Alameda Shipways Residential Project

Final Environmental Impact Report

October 2018

Exhibit 5 Item 7-A, January 14, 2019 Planning Board Meeting

Figure 3-5b <u>revised</u>. <u>Project</u> Waterfront Plan (detail) (<u>April October</u> 2018)

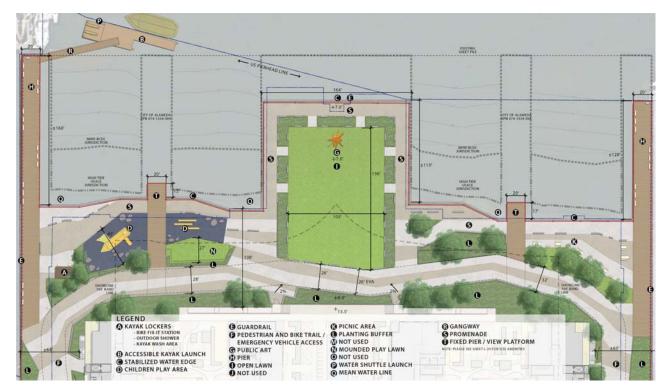
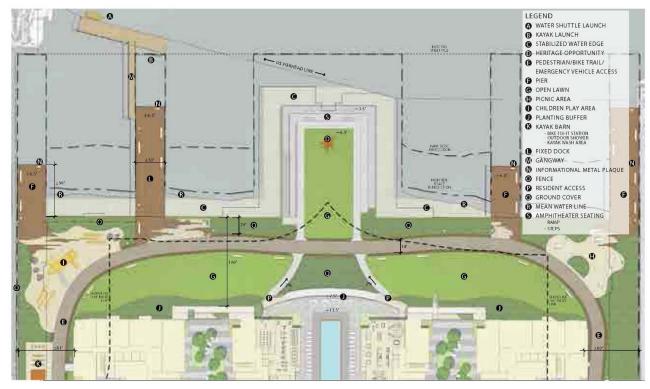
Page 3-10, Figure 3-5b; details of the waterfront plan have been revised per comments and coordination with various entities (see section 2.2 of this chapter). The revised plan is shown on the next page along with the plan as included in the Draft EIR for comparison.

Much of the existing adjacent marinas as well as other marinas in the area do not have the potential to be shielded by the project site or other structures, so such a condition was not studied in the Draft EIR. However, in response to comments, the "Alameda Shipways Residential Project – Wave Analysis" was prepared to demonstrate these conclusions, which is attached as Appendix A. This analysis concludes that post project conditions would result in wave heights similar to, or even less than, current conditions (under 1-ft in the project vicinity for both Gate 11 and Gate 10) and therefore the project will not result in significant impacts related to wave conditions. The analysis also concludes that even if the existing cofferdam were to be removed, conditions at Gates 10 and 11 would be similar to conditions at other locations within the marina, which meet the "good" standard for berthing without any shielding. Therefore, the City has determined that the project will not change wave action in the Estuary to an extent that will cause damage to boats in the adjacent marinas. The current proposed design includes construction of new sheetpile along the west (Pier 1 or craneway 1) and east (Pier 6 or craneway 6) edges of the project site, including the new piers and the existing cofferdam will be left in place. These barriers are similar to existing conditions. Figure 3-6 has been added to the EIR to clarify the Project's water edge treatment and revised Figure 3-5b shows the revised location of the water taxi/kayak dock.

- 1. Kayak kiosk building and storage racks have been eliminated and replaced with kayak storage lockers pursuant to Rec & Parks Department direction. The kayak storage area has been moved closer to the waterfront and redesigned with some enhancing planting to shield lockers.

- 2. The most western pier has been lengthened and the water shuttle dock/kayak launch has been moved to the end of this pier.
- 3. The second pier from the west, formerly the location for the water shuttle dock/kayak launch, has been reduced and a fixed pier / view platform added, pursuant to BCDC staff direction.

See revised Figure 3-5b in Chapter 2 of this Final EIR for the revised location of the water taxi/kayak dock. The water taxi will be located within the area bounded by the existing steel sheetpile cofferdam and the existing pierhead line. The end of the water taxi dock will be sited such that there will be a substantial buffer between the vessels berthed at Gate 11 and the proposed dock location to allow proposed water taxi vessels to approach and depart the water taxi dock safely. The project would not result in any increase in risk of collision compared to existing conditions, which already involves substantial ship traffic in the Estuary and the launching and docking of vessels of similar size to a potential water taxi at the berths within Gate 11.
